DRAFT Planning Commission Motion NO. M-XXXXX

Hearing Date: **October 10, 2019**
Case No.: **2014.0012E**
Project Title: **Better Market Street Project**
Zoning: Various
Block/Lot: Various
Lot Size: Various
Project Sponsor: San Francisco Department of Public Works
Cristina Olea - (415) 437-7050
Cristina.C.Olea@sfdpw.org
Staff Contact: Jenny Delumo - (415) 575-9146
Jenny.Delumo@sfgov.org

DATE: September 23, 2019
TO: Members of the Planning Commission and Interested Parties
FROM: Lisa Gibson, Environmental Review Officer
Re: **Attached Responses to Comments on Draft Environmental
Impact Report Case No. 2014.0012E: Better Market Street Project**

Figure 1: Transit stop comparison. (Source: DEIR App. 11 – Better Market Street Final Report, 2013; pp 18-19.)

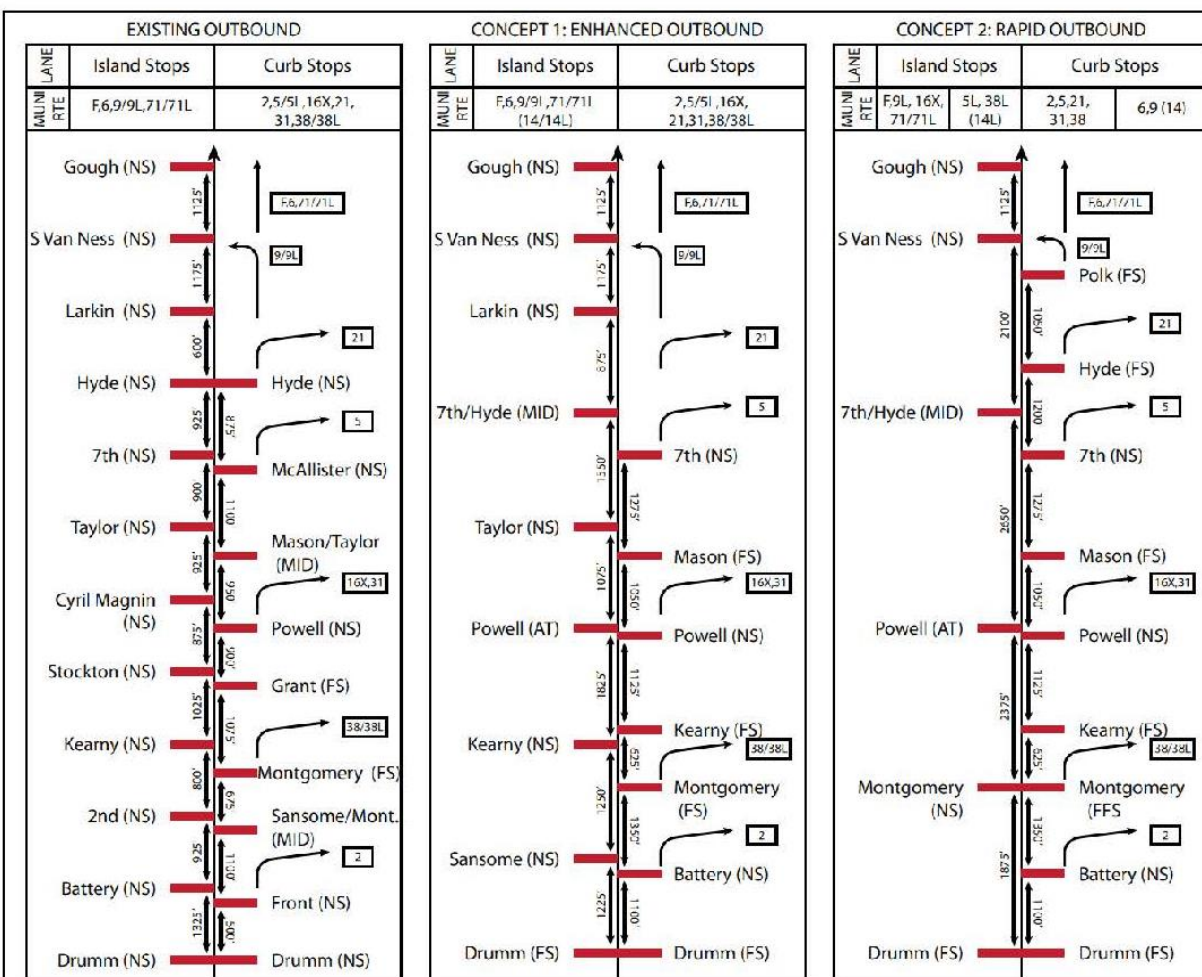
In 2013, when this proposed stop spacing was first suggested ("Rapid" stop spacing), it was proposed in conjunction with an awkward set of line assignments that separated paired Rapid from Local lines. (See Figure 1, from DEIR Appendix 11.) We concurred with staff when this set of line assignments was abandoned in favor of the more legible and convenient assignments associated with the so-called "Enhanced" stop spacings. However, staff did not then revert to those "Enhanced" stop spacings (Concept 1) that had been associated with the paired line assignments.

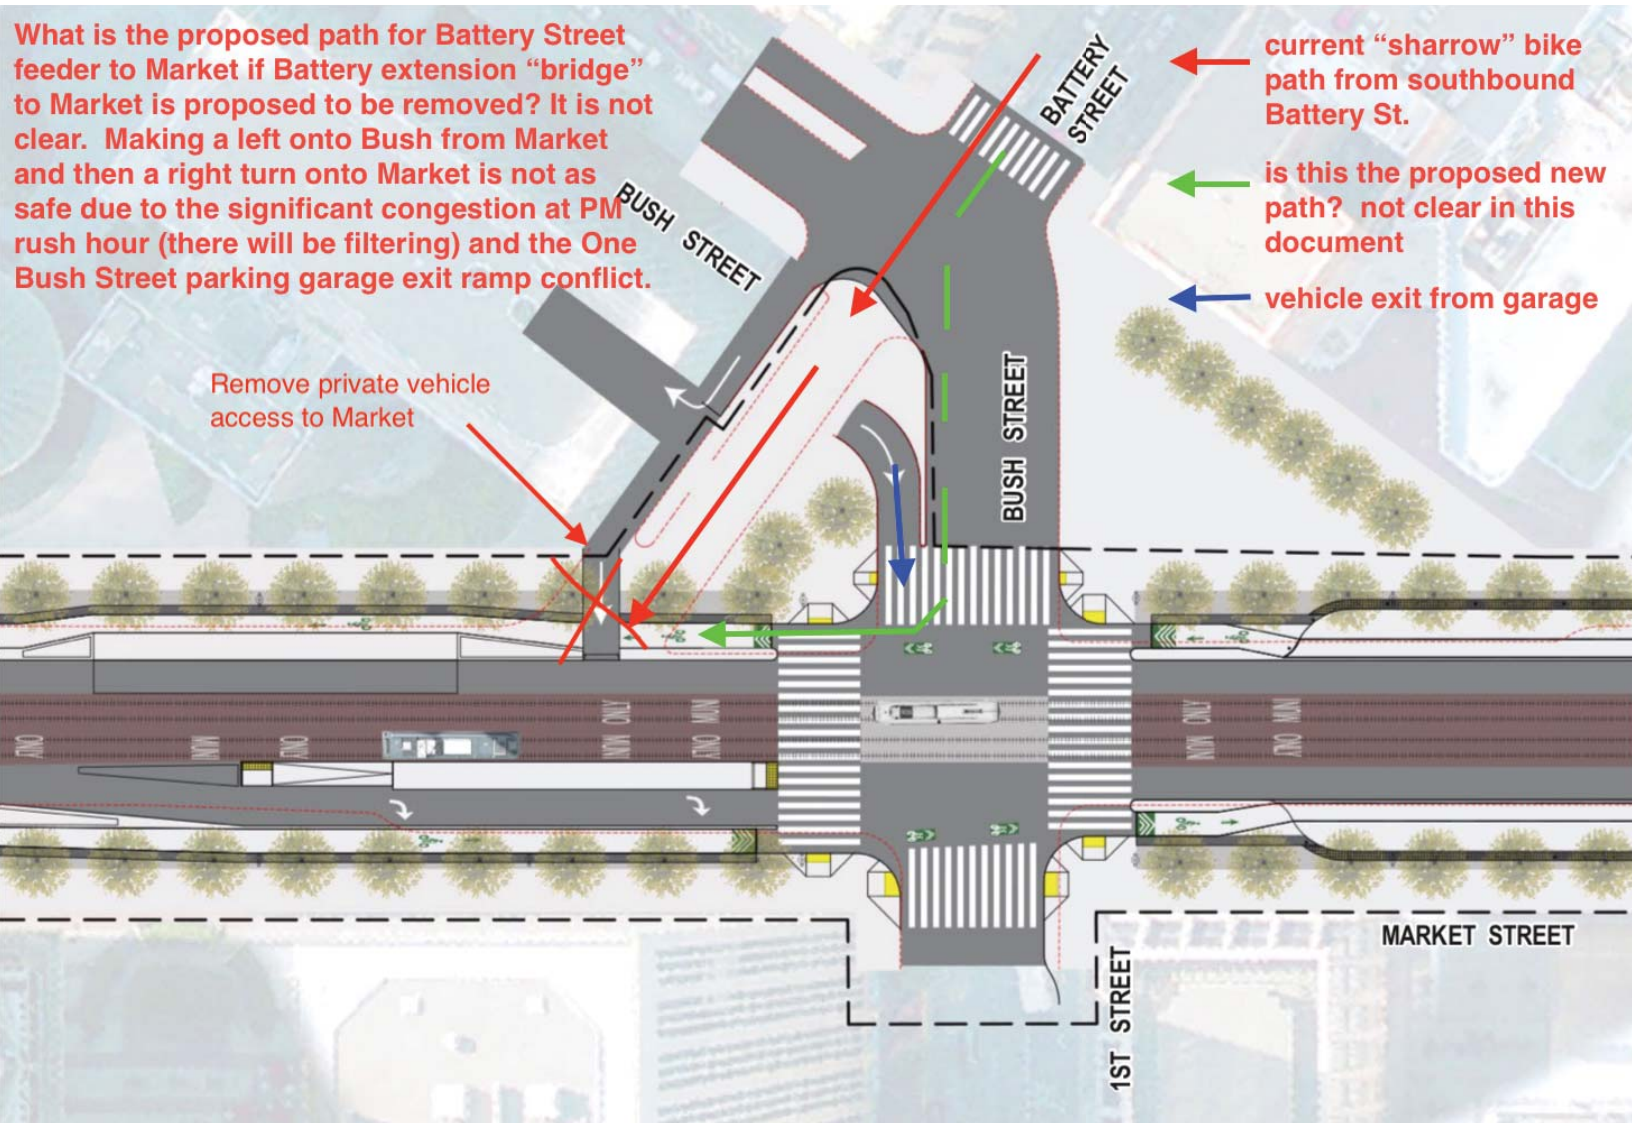
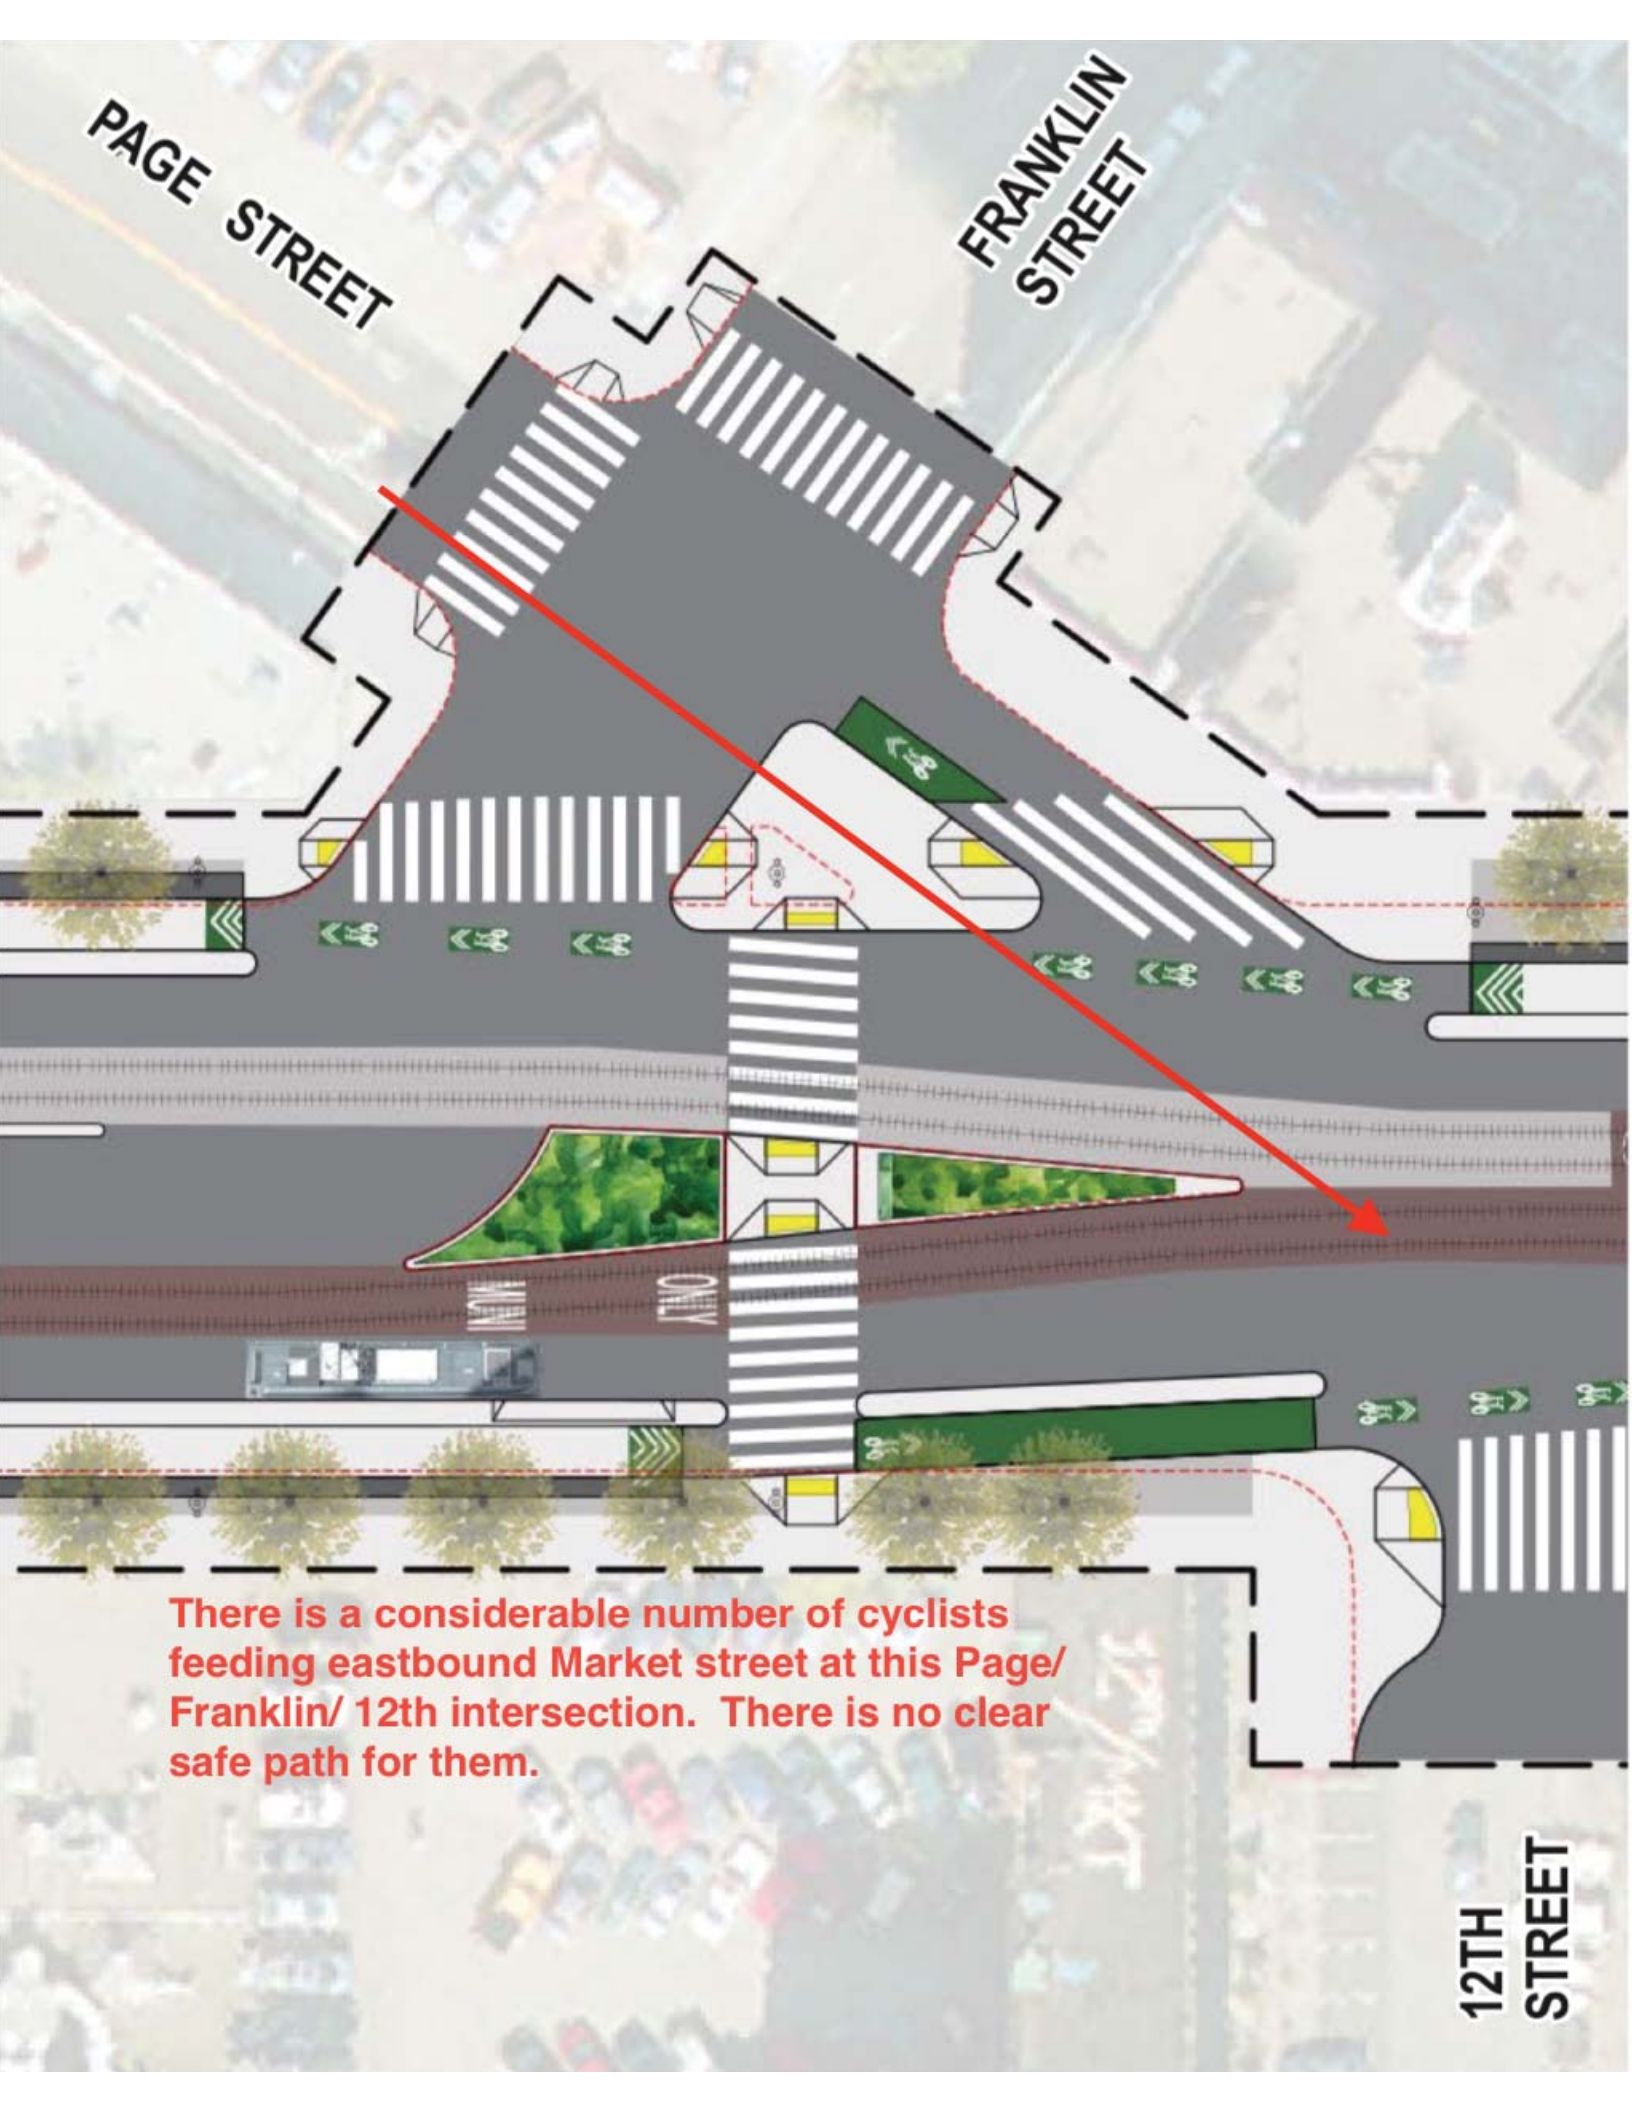
What is the proposed path for Battery Street feeder to Market if Battery extension "bridge" to Market is proposed to be removed? It is not clear. Making a left onto Bush from Market and then a right turn onto Market is not as safe due to the significant congestion at PM rush hour (there will be filtering) and the One Bush Street parking garage exit ramp conflict.

Remove private vehicle access to Market

current "sharrow" bike path from southbound Battery St.

Figure 1: Transit stop comparison. (Source: DEIR App. 11—*Better Market Street Final Report*, 2013; pp 18-19.)

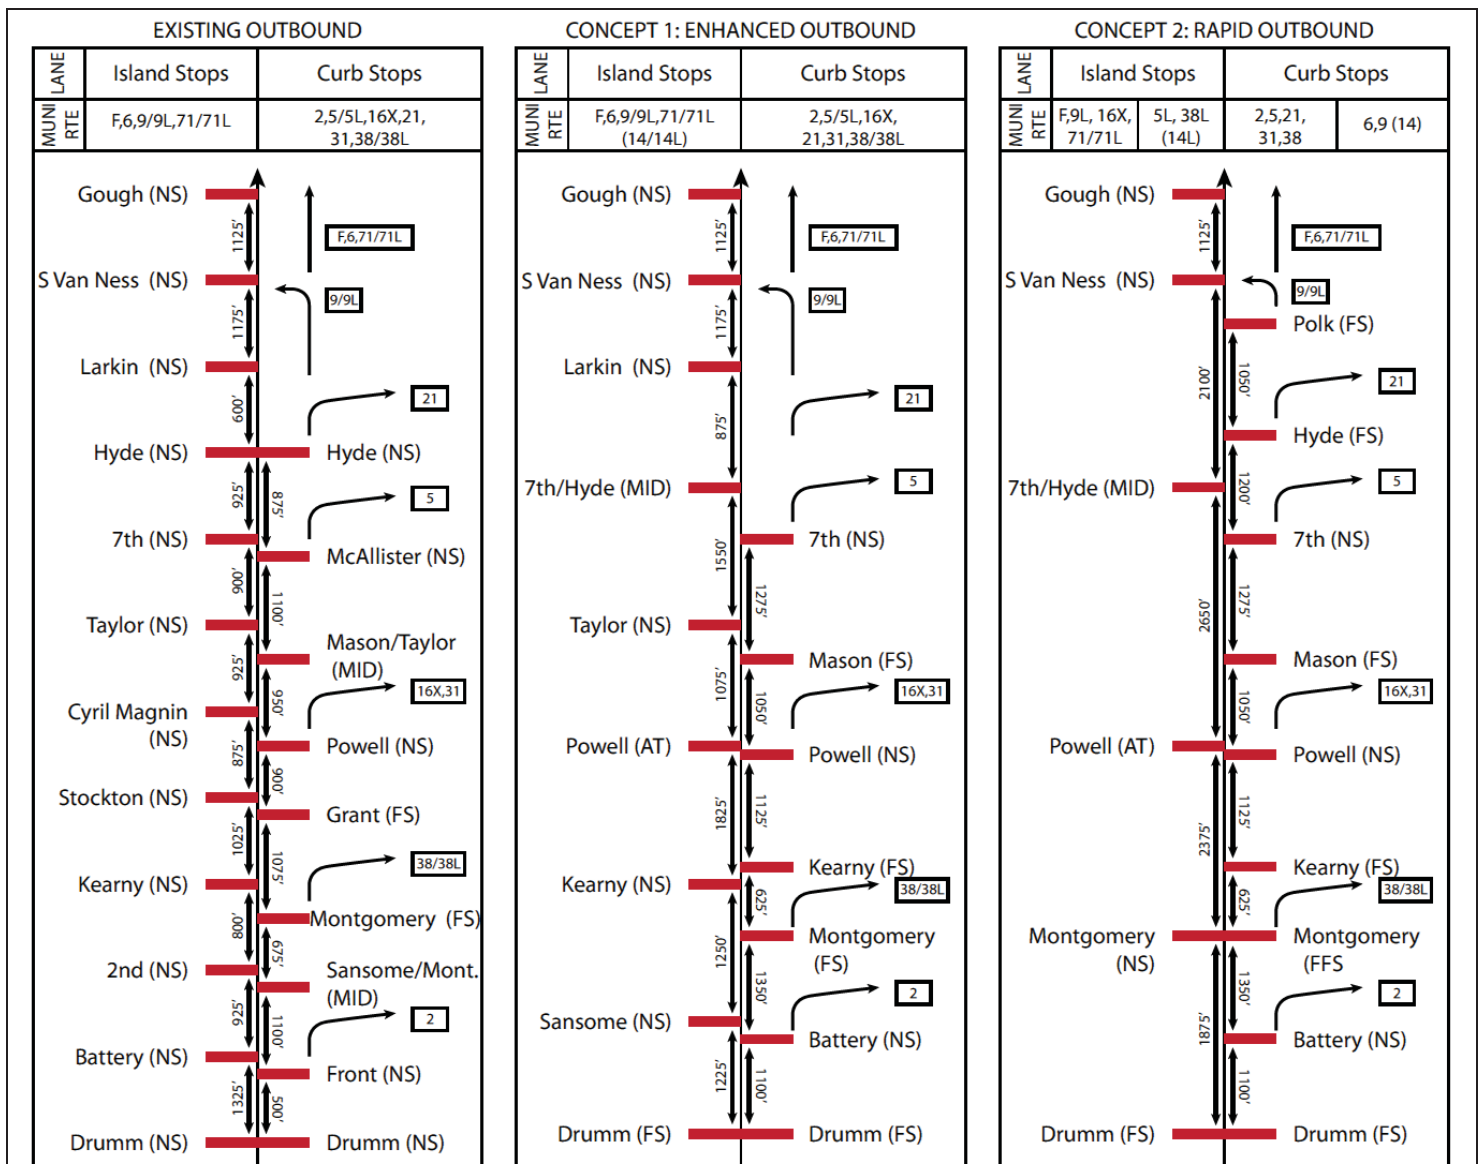
In 2013, when this proposed stop spacing was first suggested (“Rapid” stop spacing), it was proposed in conjunction with an awkward set of line assignments that separated paired Rapid from Local lines. (See Figure 1, from DEIR Appendix 11.) We concurred with staff when this set of line assignments was abandoned in favor of the more legible and convenient assignments associated with the so-called “Enhanced” stop spacings. However, staff did not then revert to those “Enhanced” stop spacings (Concept 1) that had been associated with the paired line assignments.
